SUBJECT: AMENDMENT NO. 39 TO FACILITY OPERATING LICENSE NO. NPF-43:  
(TAC NO. 67098)

The amendment revises the Technical Specifications (TS) and Bases to clarify the TS for operation with the Moisture Separator Reheater (MSR) out-of-service.

FERMI-2

SAFETY EVALUATION BY THE OFFICE OF NUCLEAR REACTOR REGULATION  
RELATED TO AMENDMENT NO.39 TO FACILITY OPERATING LICENSE NO. NPF-43

FIGURE 3.2.3-1

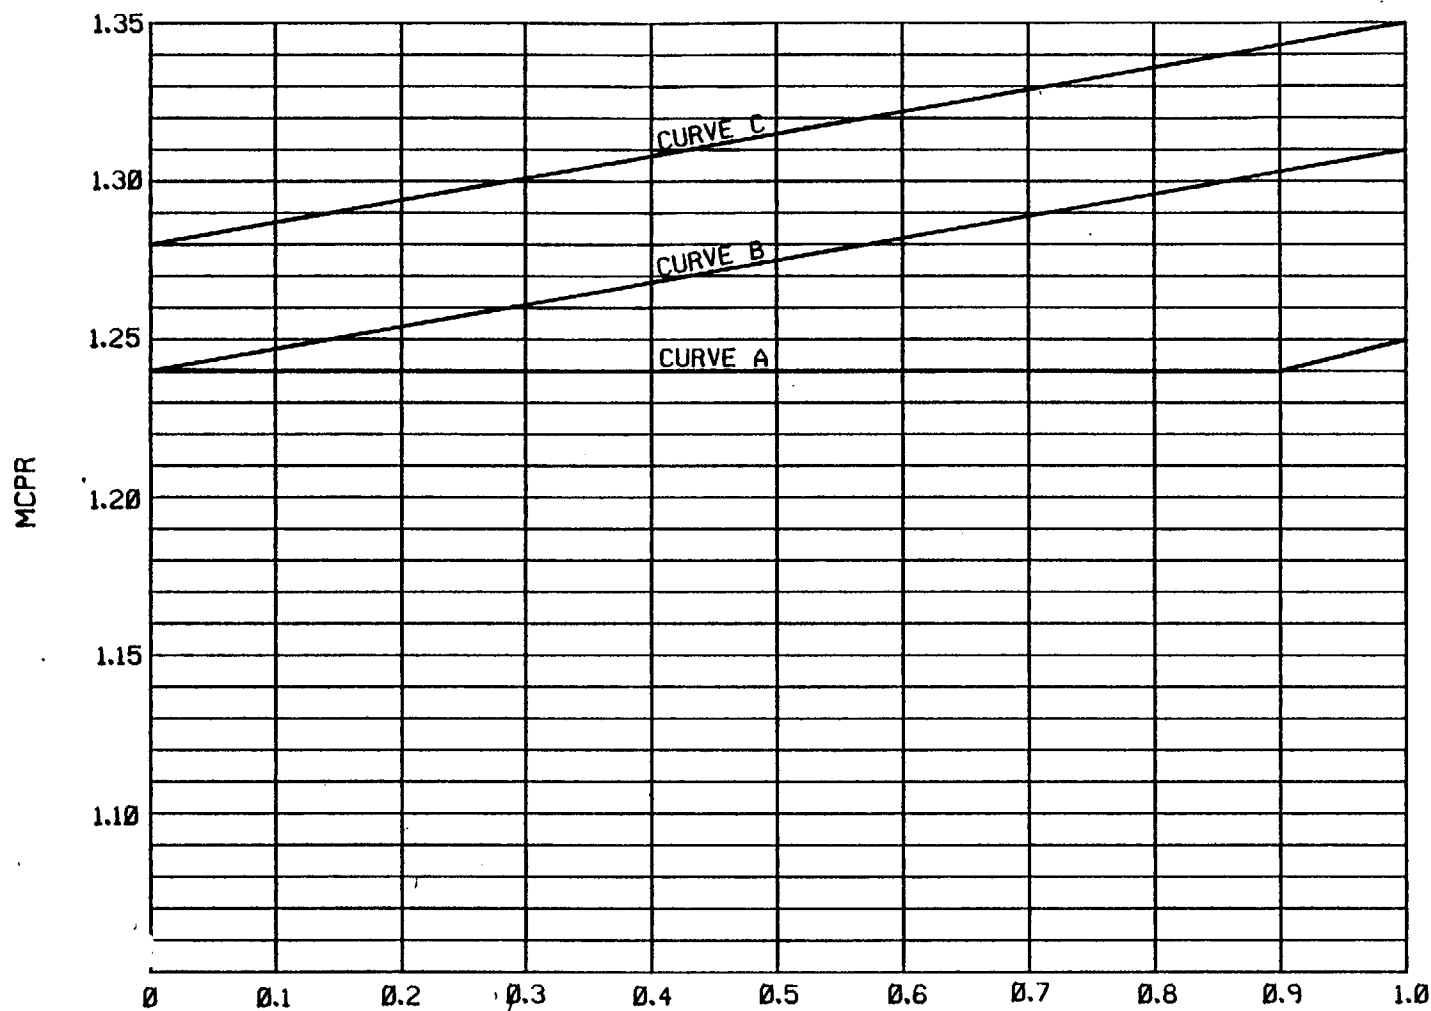
- A. Modifies Technical Specification 3/4.7.9 by specifying operation limitations of the MSR.
- B. Demonstrates conservatism to the existing transient analysis and clarifies that the limits in Technical Specifications 3/4.2.3, Figure 3.2.3.1 (Curve B) bounds the operating scenario for the MSR out-of-service.
- C. Provides an additional limitation (Curve C) to Technical Specification 3.4.2.3, Figure 3.2.3-1 for the operating scenario of an inoperable main turbine bypass and MSR out of service.

Technical Specification 3/4.2.3, Figure 3.2.3-1 Curve A provides the Minimum Critical Power Ratio (MCPR) limit assuming operation above 25 percent rated thermal power with both the MSR and main turbine system operable. Hence, the title for Curve-A in Figure 3.2.3-1 is changed to "MCPR Limit with Main Turbine Bypass and Moisture Separator Reheater" to indicate the operating condition with both.

Technical Specification 3/4.2.3, Figure 3.2.3.1, Curve B is based on the Feedwater Controller Failure with inoperable Turbine Bypass (26 percent capacity) transient analysis. This analysis bounds the case for MSR inoperable when only 10 percent bypass capability is assumed to be lost. Hence, the present Curve-B is bounding for either the Loss of Turbine Bypass capability or the Loss of MSR. The proposed title for Curve-B applying the Curve-B for situations without Main Turbine Bypass or without Moisture Separator Reheater is acceptable.

The proposed Curve-C in Figure 3.2.3.1 provides the MCPR Limit with both the Turbine Bypass and MSR inoperable. The curve was developed based upon the Limiting Feedwater Controller Failure with no Steam Flow Bypass through Turbine Bypass or MSR. The calculated MCPR 1.28 for this scenario is sufficiently higher than the MCPR Safety Limit of 1.06. The staff finds this acceptable.

CURVE A - MCPR LIMIT WITH MAIN TURBINE BYPASS AND WITH MOISTURE SEPARATOR REHEATER  
CURVE B - MCPR LIMIT WITHOUT MAIN TURBINE BYPASS OR WITHOUT MOISTURE SEPARATOR REHEATER  
CURVE C - MCPR LIMIT WITHOUT MAIN TURBINE BYPASS AND WITHOUT MOISTURE SEPARATOR REHEATER
